2007 Chapter 1341 ANSI A117.1 Figure Corrections

Link to International Code Council Errata:
www.iccsafe.org/cs/standards/a117/2003Errata.pdf

Fig. 608.2.1
Transfer-Type Shower Compartment
Size and Clearance

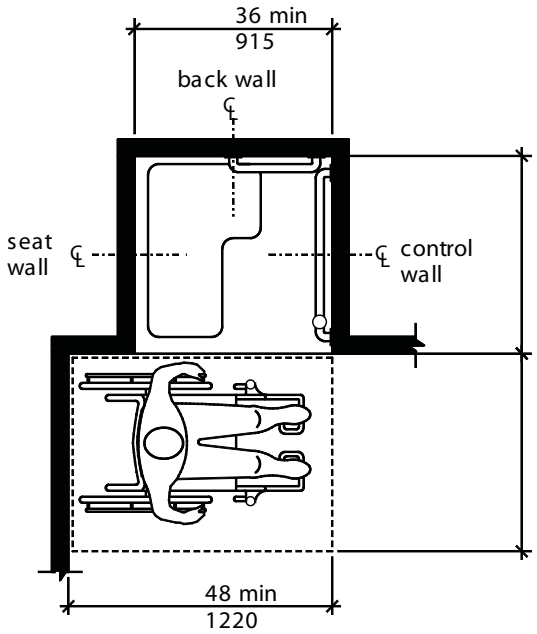
Back wall dimension should be 36 inches, not 36 min.

Fig. 608.5.3
Alternate Roll-in-Type Shower Control and Handshower Location

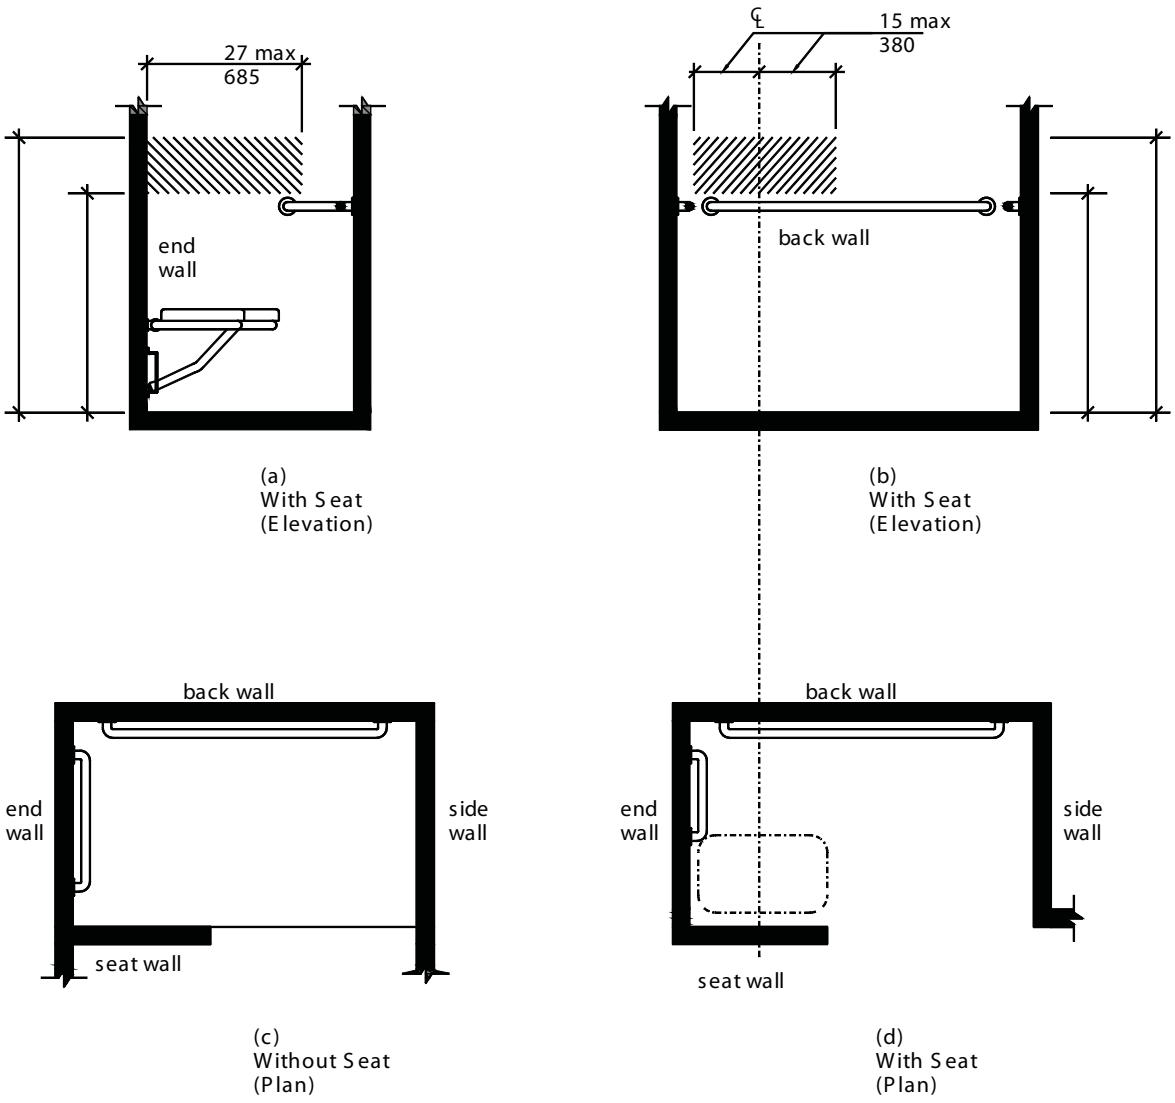
Figure (c) should be deleted. All showers are required to provide a seat.
